**MEETING AGENDA  
CITY OF BANDON PLANNING COMMISSION  
THURSDAY, JULY 25<sup>TH</sup>, 2024 - 7:00 P.M**

**SUBJECT:** **5.1 24-007, A REQUEST FOR APPROVAL OF A CONDITIONAL USE PERMIT TO REMODEL AND ENLARGE AN EXISTING CHURCH (HOLY TRINITY CATHOLIC CHURCH) AT 355 OREGON AVE SE IN THE CITY OF BANDON.**

Re: Holy Trinity Church Building - Conditional Use Permit,  
Application File Name (#): 24-007

### EXISTING SITE LIGHTING

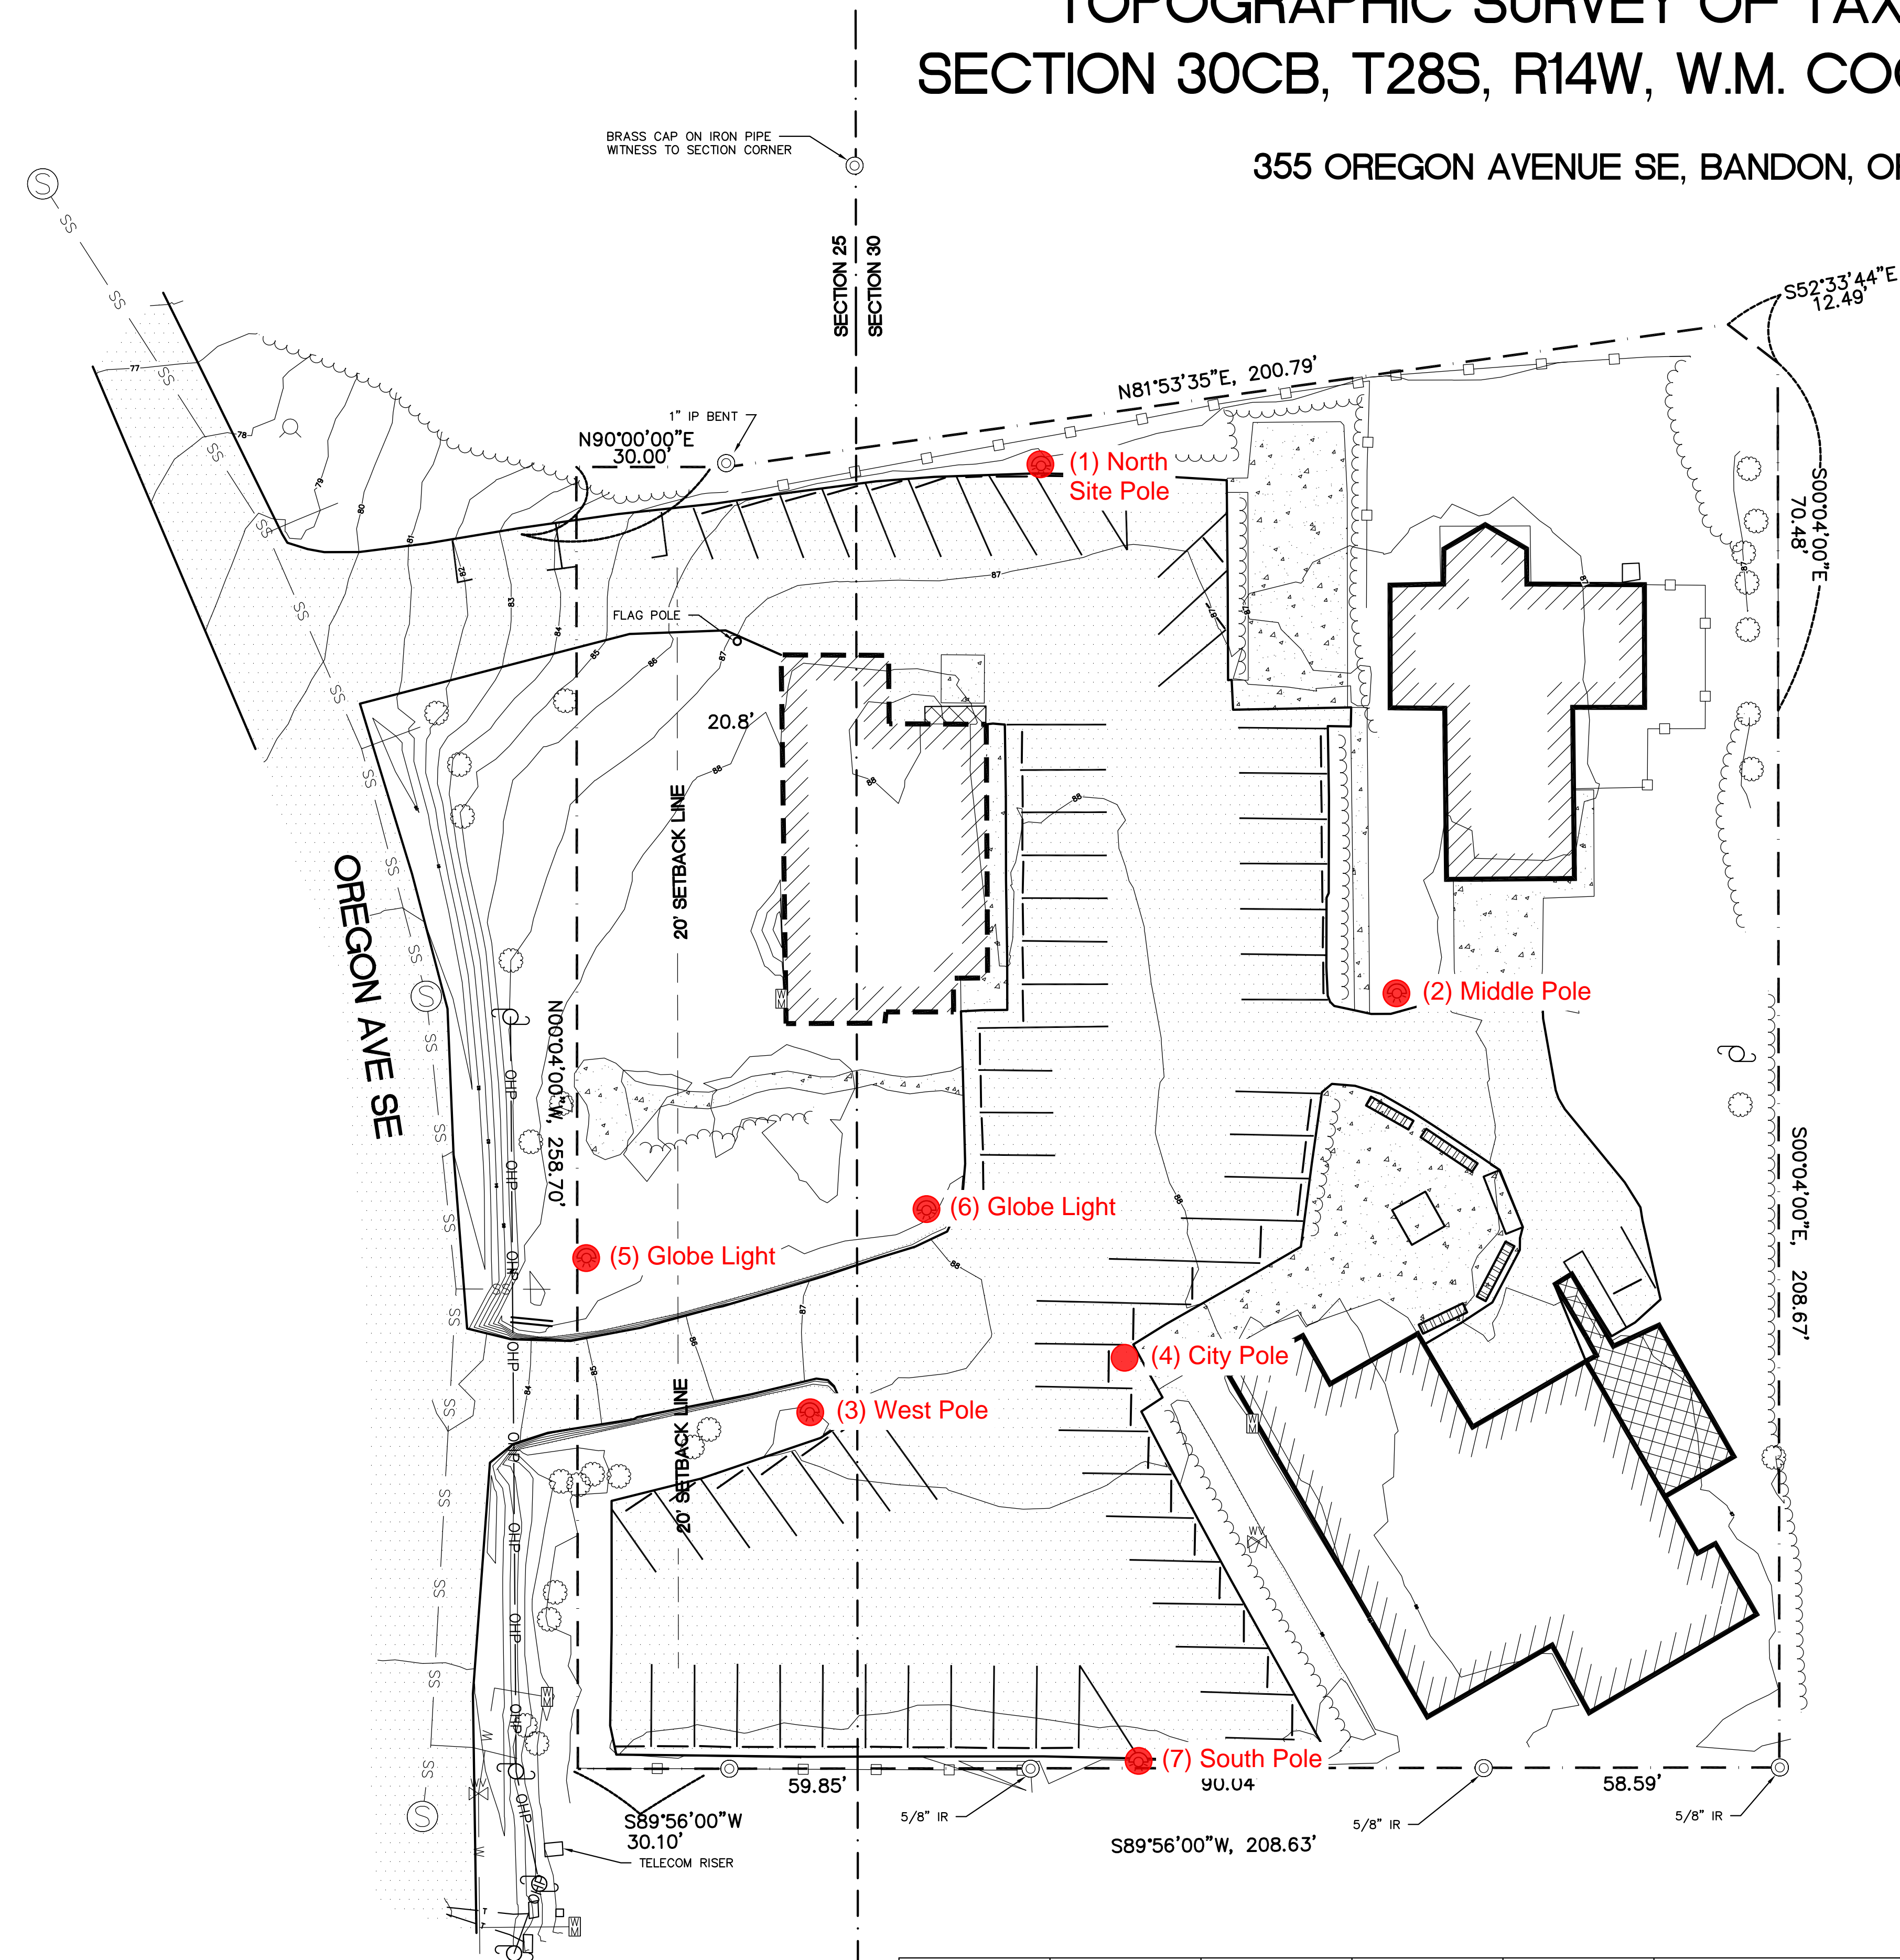
The **EXISTING SITE** has the following: **(7) light poles, with (21) lamps or heads:**

1. North pole with (3) heads,
2. Middle interior pole on east side with (3) heads
3. Middle interior pole, west side at entry drive with (2) heads
4. City light pole with high-glare unshielded street light (1) head
5. Decorative short pole, adjacent to Oregon Ave. SE, with high-glare (5) globe lights,
6. Decorative short pole, interior of site, with high-glare (5) globe lights
7. South pole with (2) heads, 1' setback from property line.

**1 SITE LAYOUT PLAN - PROPOSED SITE LIGHTING**  
SCALE: 1" = 20'

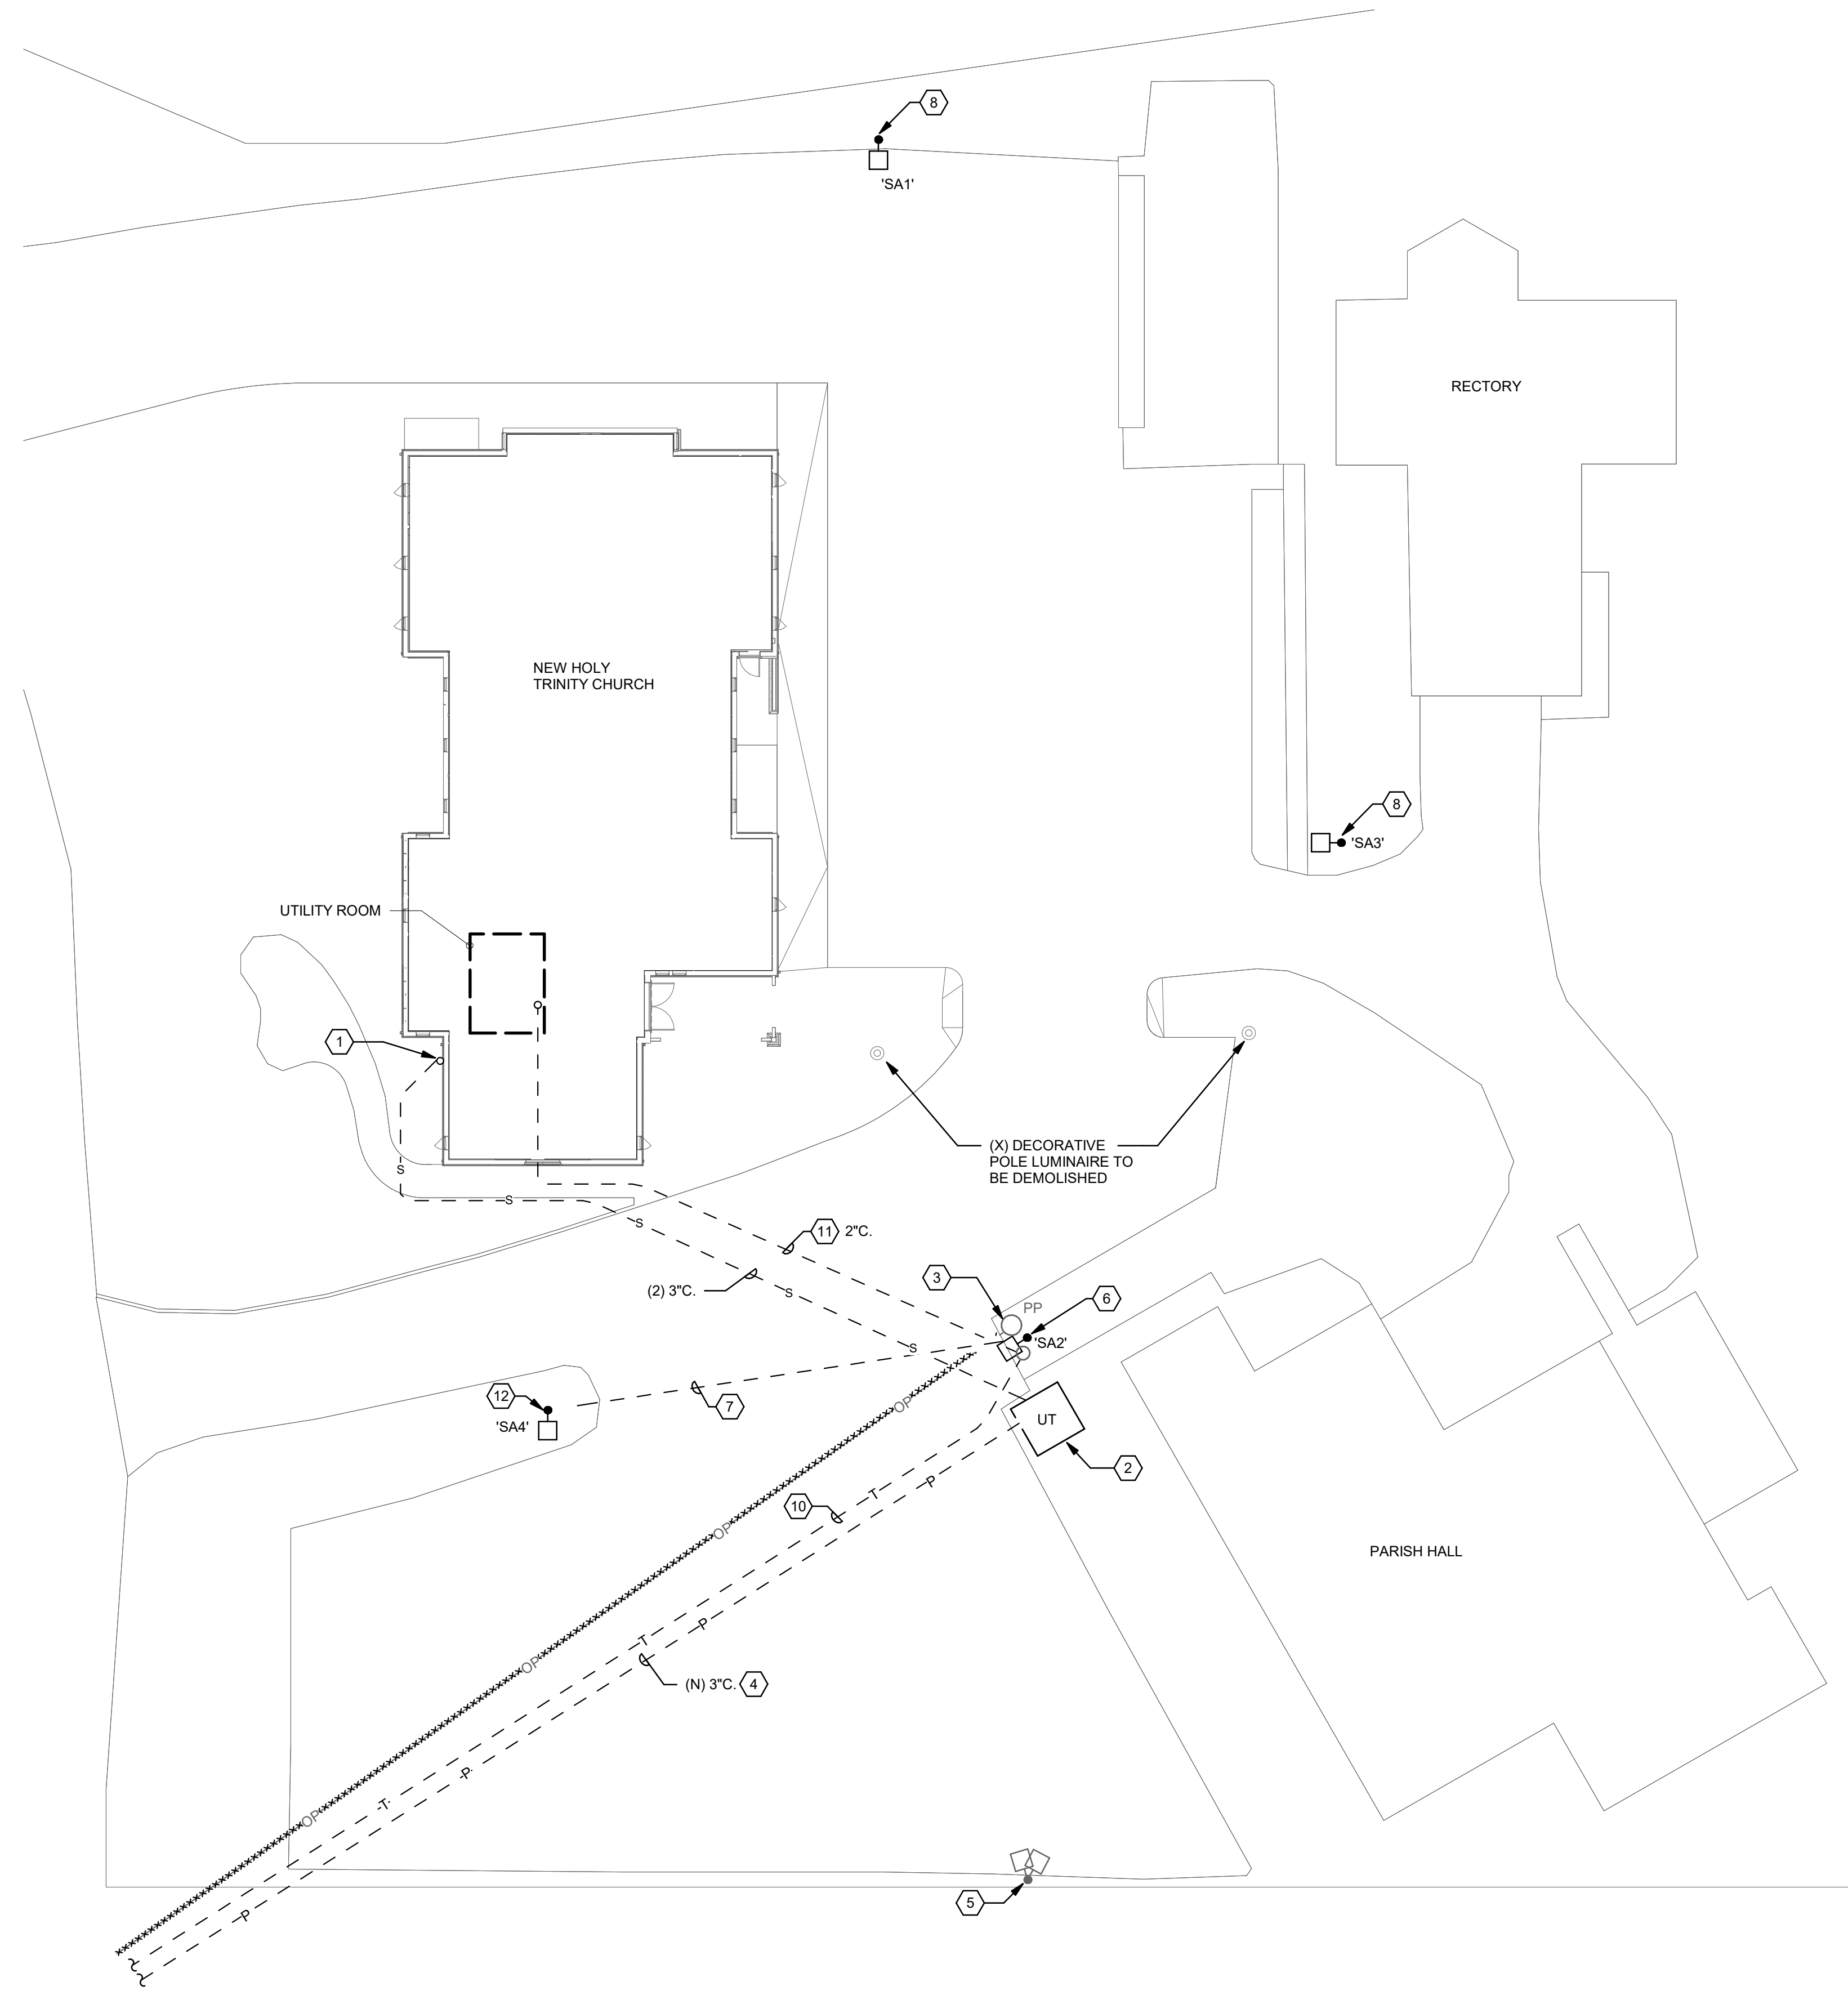
The **PROPOSED SITE LIGHTING** will have **(4) poles with (4) heads:**

1. North pole with (1) head with cut off feature, as proposed originally.
2. Middle interior pole on east side with (1) heads.
3. Middle interior pole, west side at entry drive with (1) head
4. Replace city light pole with pole/mounting height same as others, east side (1) head.
5. Remove South pole.

1. Replace ALL fixtures on all (4) poles with nightsky/full cut off/all downlight/no uplighting. See attached cut sheet, sent previously.

2. Reduce height of light fixtures by removing light fixture mounting arms from top of existing poles, mount replacement lights on the side of the pole, reducing the height by about 2.5'. See sketch.
3. Replace City interior street light/power pole with (1) light pole and fixture, same as above.
4. Provide "house" shielding/backlight control at north and south poles, same as previously submitted and explained during hearing.
5. Existing high-glare "Globe" decorative light poles (2) to be removed.
6. Remove south pole.
7. All lights will have Integral motion/ambient sensor with integral bi-level dimming device to switch the luminaire to at least 50% light output.
